Clarissa Rowe and Brian Rehrig  
Arlington Land Trust  
[clarissa.rowe@comcast.net](mailto:clarissa.rowe@comcast.net)  
[brehrig@alum.mit.edu](mailto:brehrig@alum.mit.edu)

RE Letter of Recommendations for the Zoning Board of Appeals Meeting – Dec. 22, 2020  
Climate Change Considerations for the East Arlington Mugar Site

Figure 1. FEMA Flood Map

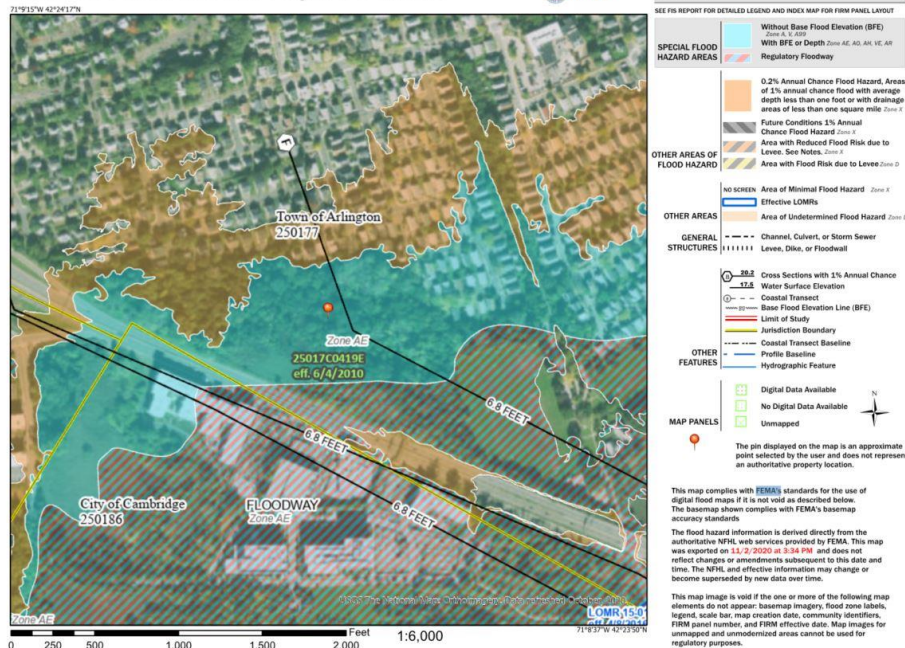
- **Current design relies solely on regulatory FEMA base flood elevation (Zone AE, 100-yr floodplain, flood elevation of 6.8 ft-NAVD88 elevation)**
  - o The site is located in Zone AE AND Zone X (500-yr floodplain, FEMA elevation 10.7 ft-NAVD88)

- o FEMA design does not consider Sea Level Rise / Storm Surge Effects due to climate change
- **Neighboring communities HAVE considered these effects in their design**

Commented [HA1]: Use this from Cambridge tool or FIS flood profile elev.?

Figure 2. Arlington BH-FRM Map

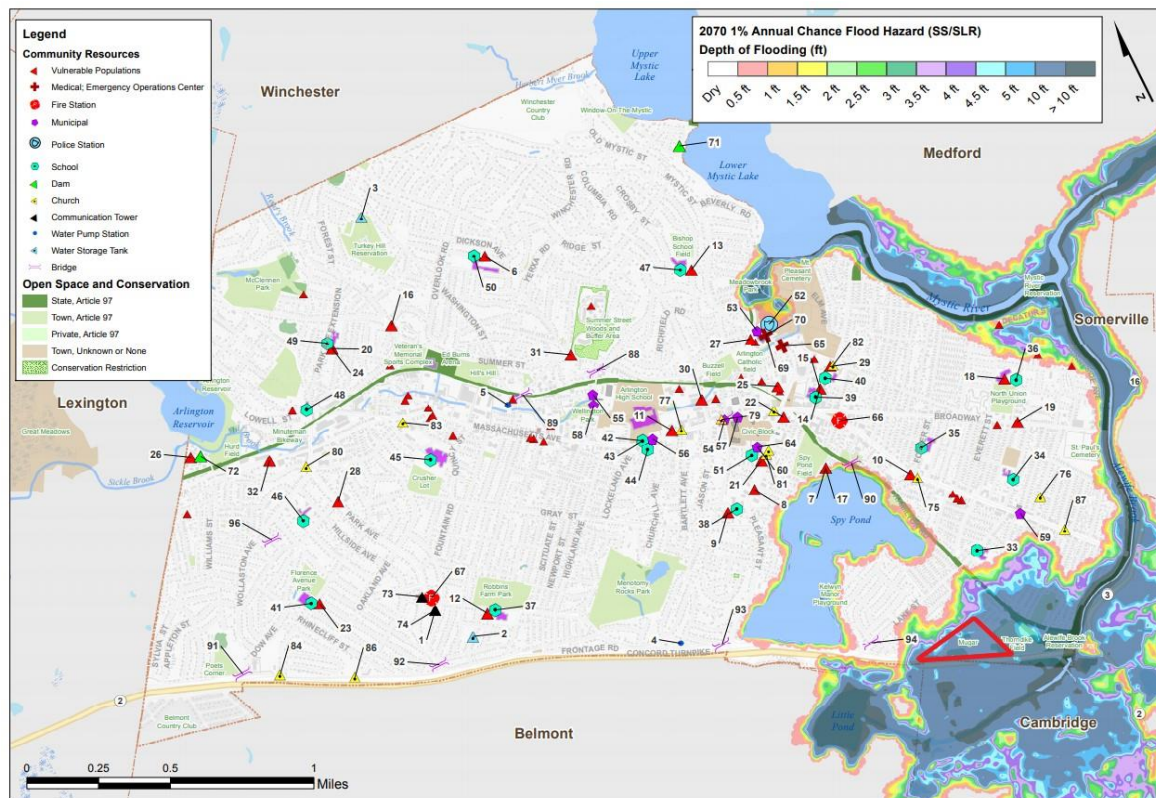
- o Cambridge & Boston
    - Boston and Cambridge have included coastal flood resilient design that accounts for latest sea-level rise (SLR) and storm surge (SS) projections from the Boston Harbor Flood Risk Model developed by the Woods Hole Group for MassDOT. These projections are currently being updated as part of the Massachusetts Coastal Flood Risk Model (MC-FRM), which will serve as new design standards for buildings and infrastructure projects across the Commonwealth and will be recommended that cities and towns adopt.

- Prior to the MC-FRM flood elevations being available, the BH-FRM elevations can serve as a minimal estimate of future projections at the proposed site, as the MC-FRM has consistently projected higher elevations for adjacent areas.

- The BH-FRM results estimated that both the Amelia Earhart Dam (AED) and the Charles River Dam are likely to be flanked 10-15 years before they are likely to be overtopped. This indicates that the local crest elevations and pump systems are more resilient to flood potential than the surrounding landscape. According to the Cambridge Climate Change Vulnerability Assessment, the AED is likely to be flanked by 2035 and overtopped by 2045.

- If the Amelia Earhart Dam is flanked and overtopped, it implies that the coastal flooding from the Boston Harbor will affect the proposed development site, and the site is likely to experience a greater than 20% annual probability of flooding by 2070.

Figure 3. Comparison of Design Storm Depths

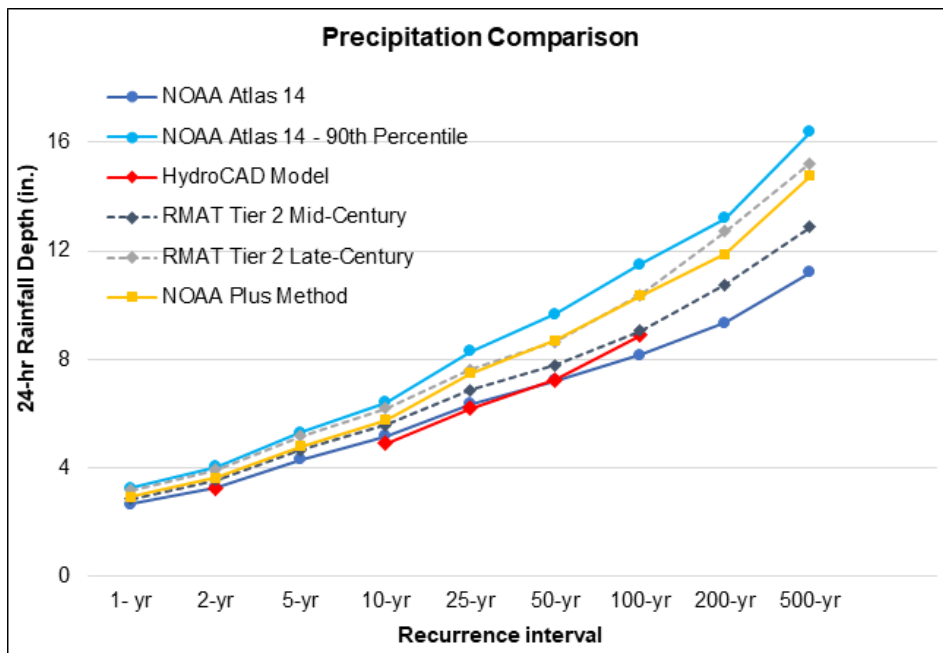
- The design storm depth values used for their HydroCAD analysis may meet the rainfall conditions outlined above, but do not consider the increased magnitude of storm events predicted out to the 2070s planning horizon.

- **Future MassDEP Standards – NOAA Plus Method (Solid Blue Line figure X)**
  - The MassDEP Stormwater Advisory Committee Meeting September 22, 2020, MassDEP is considering updating the wetlands regulations to “incorporate the risk observed in the current data to reflect the range of larger storms.”

- This NOAA Plus Method takes 90% of the NOAA Atlas 14 Estimates Upper Confidence Interval. This method will increase the stormwater basin size at most locations.

- Climate resilient design for the average level of effort, as proposed by the RMA Standards, include percent increases for NOAA Atlas 14 Estimates. These percent increases for the mid- (2030/2050) and late-century (2070/2090) show greater design storm depths than used by the BSC Group. A comparative representation of the precipitation depths discussed in this letter is shown in Figure 3, below.
